# Comments on ECE/TRANS/WP.29/GRSG/2011/14 (Draft amendment to Regulation No. 67/01 by the expert from the Netherlands)

Figure 1, amend as follows:

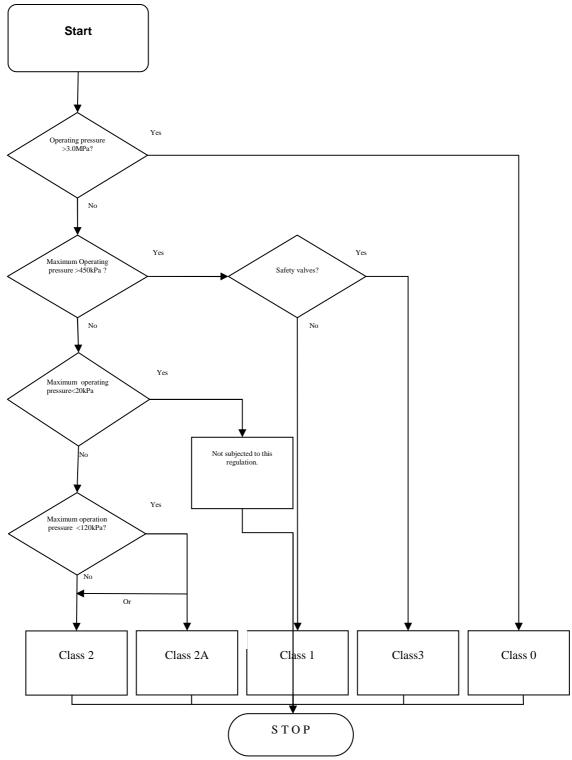
Paragraph 2, amend the text to read:

"Class 0 High pressure parts including tubes and fittings containing liquid LPG with a pressure  $> \ge 3,000 \text{ kPa}$ "

## **Justification:**

According to the present definition, that is not intended to be modified by the document ECE/TRANS/WP.29/GRSG/2011/14, Class 1 includes parts containing liquid LPG at pressure equal to 3,000 kPa. Then, Class 0 has to include parts containing liquid LPG at pressure above 3,000 kPa.
